PRODUCT CHANGE NOTICE

Package Orientation Change for Tray Packing of the Listed Intersil Products

**Refer to:
PCN12066**

Date: August 8, 2012

Products ISL8200MIRZ

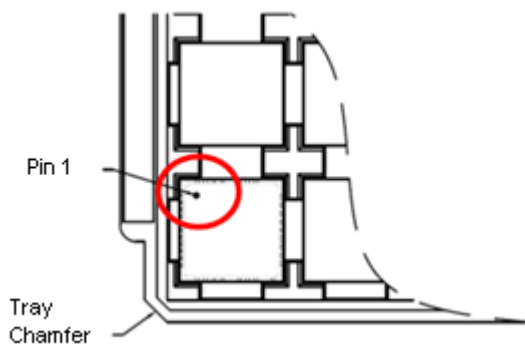
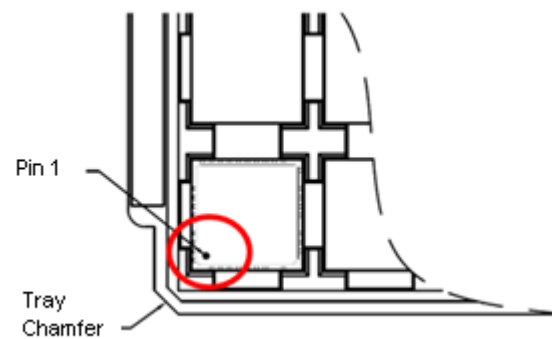
This notice is to inform you that Intersil is changing the package orientation for tray packing of the listed QFN (Quad Flat No-Lead) plastic packaged products. The change in package orientation aligns pin 1 of the device with the tray chamfer/notch and is in accordance with established industry standards for packing of IC products. Diagrams depicting the changes in package orientation are included on the next page for reference. There will be no change in the trays (i.e. dimensions, materials, appearance, etc.) used for product shipment.
